# UNITED STATES PATENT AND TRADEMARK OFFICE

APPLICATION NO.	FILING DATE	FIRST NAMED INVENTOR	ATTORNEY DOCKET NO.	CONFIRMATION NO.
10/722,332	11/24/2003	Kazuhisa Takayama	60280 (70904)	6559
21874	7590	02/09/2006	EXAMINER	
EDWARDS & ANGELL, LLP P.O. BOX 55874 BOSTON, MA 02205			FALASCO, LOUIS V	
			ART UNIT	PAPER NUMBER
			1773	
DATE MAILED: 02/09/2006

<b>Office Action Summary</b>	<b>Application No.</b> 10/722,332	<b>Applicant(s)</b> TAKAYAMA ET AL.	
	<b>Examiner</b> Louis Falasco	<b>Art Unit</b> 1773

DETAILED ACTION

FIG. 6 (b)

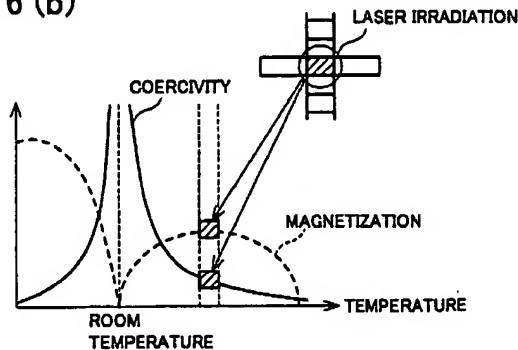
With regard to the second magnetic layer having '*peak absolute value of total magnetization*' greater than the first magnetic layer: though this has not been claimed in US Patent No. 6678219 the claims of US Patent No. 6678219 are based on the disclosure of a magnetic recording media having a first magnetic layer (layer 3) developing flux lines for a imaging layer where the second magnetic layer laser imaging or recording (layer 4). For this relationship the first magnetic layer must have a compensation temperature lower than the second, to allow only the second magnetic layer to be imaged by the laser (see **Hirokane et al** disclosure at col. 5 lns 16-21), similarly this temperature relationship provides for the imaging or recording in the second magnetic layer in the instant claims as illustrated in instant Fig. 6(a) where magnetic flux goes through by the first layer and magnetic pattern held in the second layer necessarily be

at the higher (laser) temperature as illustrated by instant Fig. 6(b) in the square recording area at the temperature of laser irradiation, optimally at highest magnetization point.
